**Borough of Freehold
Planning Board
Agenda No. 21-07
April 14, 2021**

**RE: COMPLETENESS REVIEW
JONATHAN MARSHALL – 82 COURT STREET
FINAL SITE PLAN & USE VARIANCE REQUEST
BLOCK 37, LOTS 1.02
BOROUGH OF FREEHOLD, MONMOUTH COUNTY, NEW JERSEY**

**RE: JONATHAN MARSHALL – 82 COURT STREET
ENGINEERING REVIEW
SITE PLAN AND VARIANCE REQUEST
BLOCK 37 LOT 1.02
BOROUGH OF FREEHOLD, MONMOUTH COUNTY, NEW JERSEY**

LAYOUT PLAN

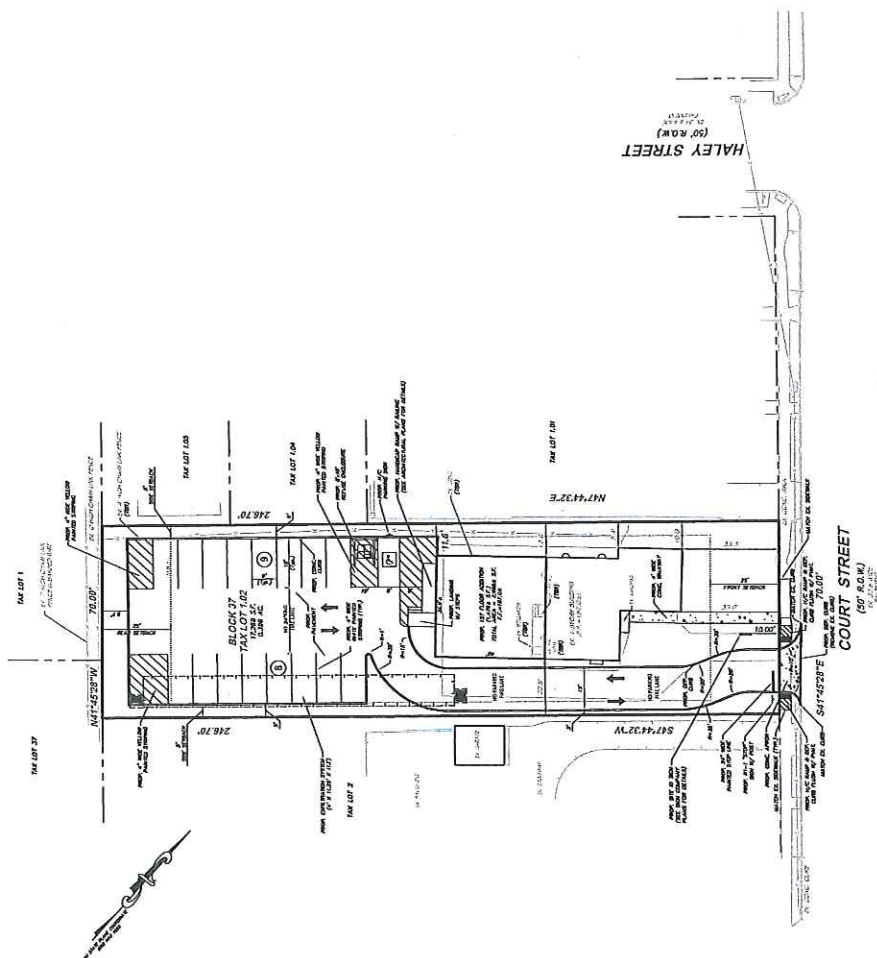
3. The applicant should review with the Board the changes to the building exterior, and proposed building access points.
4. General Note #9 on sheet 1 of the Site Plans indicates building footprint is based on an architectural plan set. Architectural plans were not received by our office.

5. The applicant should review handicapped accessibility. Sheet 3 of the Site Plans references architectural plans in regard to a proposed handicapped ramp with railing at the rear of the building addition. Plans, details and grading for the ramp and railing were not received by our office, and should be provided, in accordance with ADA requirements.

CONSTRUCTION DETAIL SHEET

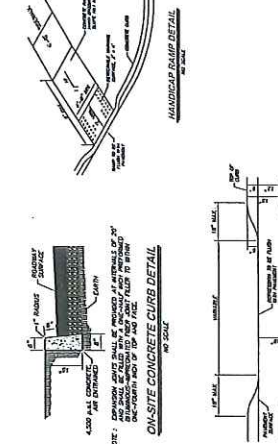
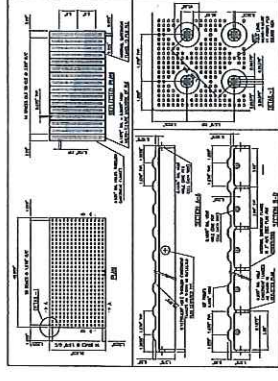
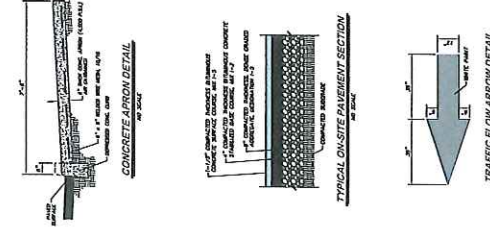
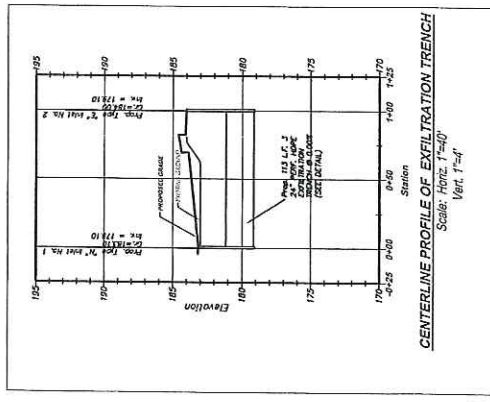
6. The detail for the type 'E' inlets on sheet 5 indicates the use of open bottoms, with stone beneath. The stormwater report should further clarify the use of recharge inlets.

1. Sheet 5 of the Site Plans indicates a soils review to a depth of 60 inches (5.0 ft). This would equate to an elevation of 178.00. With a bottom elevation of the underground exfiltration system at 178.10, additional seasonal high water table analysis should be performed to confirm a separation space from the bottom of the stormwater management system. It is recommended that a minimum of 2 foot separation be provided.

1. The plans indicate one (1) proposed free standing identification sign, in the front yard, set back 10 feet from the front lot line.
2. The sign detail on sheet 5, indicates a proposed sign face of 36 in x 48 in., mounted on 2 posts. The sign face comprises 12 square feet.
